ATTACHMENT 3

Marked-up Current
South Texas Project Technical Specifications
Reflecting Proposed Changes
to the
Shutdown Margin Technical Specification

Attachment 3
ST-HL-AE-4222
PAGE 1 OF 4

FIGURE 3.1-1
REQUIRED SHUTDOWN MARGIN VERSUS RCS CRITICAL BORON CONCENTRATION
(MODES 1, 2, 3, AND 4)

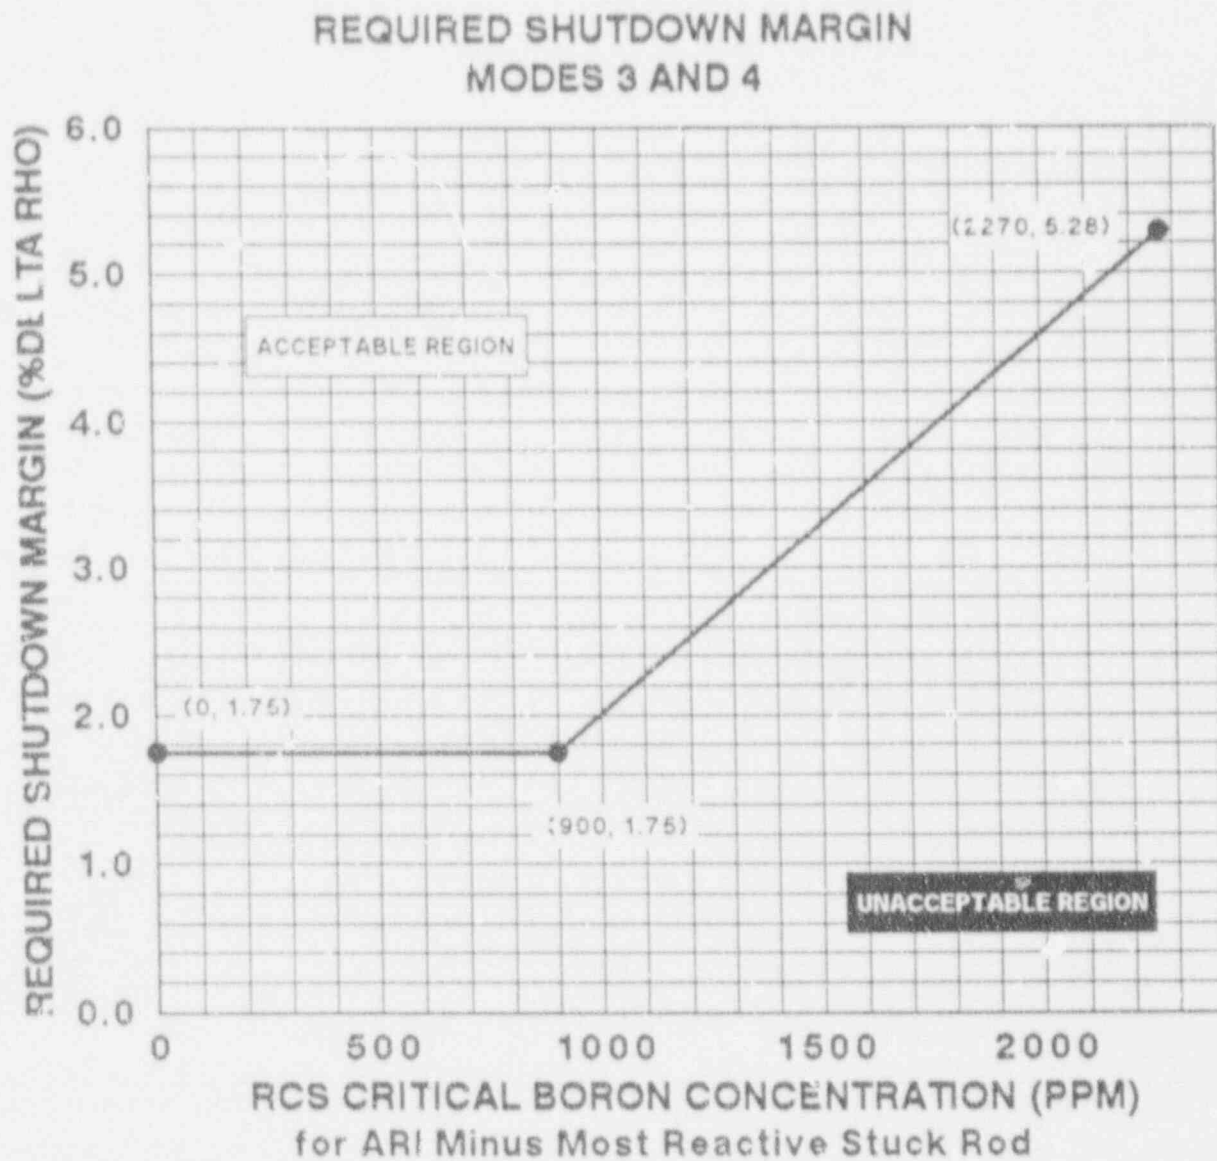
REPLACE WITH NEXT PAGE

REQUIRED SHUTDOWN MARGIN
FOR MODES 1 AND 2:
1.75% DELTA RHO
